AGENDA ITEM SUMMARY REPORT

- APPLICATION NO.:** Coastal Development Permit 9-18 (CDP 9-18)
Design Review 3-18 (DR 3-18)
Minor Subdivision 1-18 (DIV 1-18)
- OWNER:** Wayne Mayhew
- APPLICANT:** AutoZone Parts, Inc. – Mitch Bramlitt

- AGENT:** LACO Associates
- PROJECT:** Coastal Development Permit, Design Review, and Minor Subdivision to construct a 7,500 SF AutoZone retail store with 26-space parking lot and associated improvements and infrastructure. The existing 2.5-acre parcel is vacant and the proposed subdivision would create two lots. Lot 1 on the northern portion of the site would be the site of the proposed retail store. No development is proposed for the southernmost lot at this time.

- LOCATION:** 1151 S Main Street, Fort Bragg
- APN:** 018-440-58
- LOT SIZE:** 2.5-acres
- ACTION:** The Planning Commission will consider adoption of the project Mitigated Negative Declaration; and approval of Coastal Development Permit (CDP 9-18), Design Review (DR 3-18), and Minor Subdivision 1-18 (DIV 1-18)

Image 5: Aerial of View Corridor

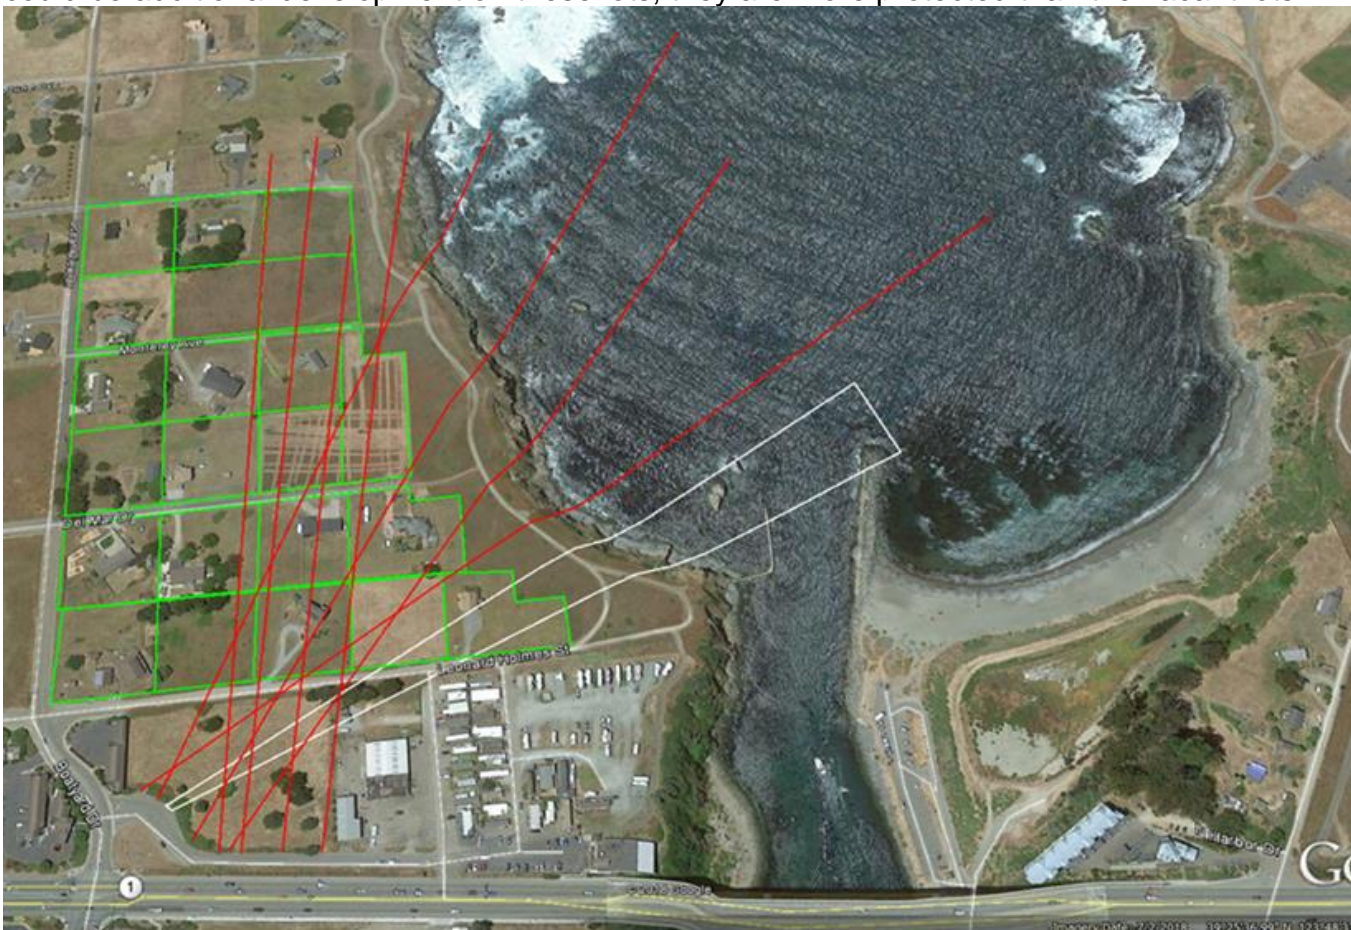
Visual Resources – The proposed project location is not identified as a potentially scenic view on Map CD-1 of the Coastal General Plan. However, this vacant site and the numerous vacant residential parcels in the County located west of the site, offer views to the ocean and a general

open space quality. Staff conducted a site visit with California Coastal Commission staff to determine how best to protect views to the ocean through the site. It was decided that a “View Easement” would be the best tool for protecting blue water views from the proposed development and any future potential development. The view easement would be clearly illustrated on the Plat to be recorded as a deed restriction and permanent exhibit to the deeds as a condition of the subdivision (see mitigation measure LAND-2). With mitigation incorporated, the project will have a less than significant impact on blue water visual resources.

In selecting the most protected view easement, the adjacent parcels were considered because many existing views cross through vacant lots. The aerial image below depicts several views from the unnamed frontage road. The red lines offer expansive blue water views today, however cross through vacant parcels that are zoned for residential units and will likely be developed. The white corridor crosses through the center of site and stretches toward Noyo Harbor. Although there could be additional development on these lots, they are more protected than the vacant lots.

In collaboration with Coastal Commission staff, staff proposes that an easement protecting the view associated with the white view corridor illustrated in Aerial 5, would meet these Coastal General Plan requirements, and therefore the MND includes Mitigation Measure LAND-2 to ensure preservation of this view corridor.

LAND-1: Wooden fencing, such as split rail fencing, with a maximum height of 48 inches and native and drought tolerant landscaping shall be installed along the entire western length of the property. The fencing and landscaping shall be included as part of the final Landscaping Plan to be approved by the Community Development Department, prior to issuance of building permit.
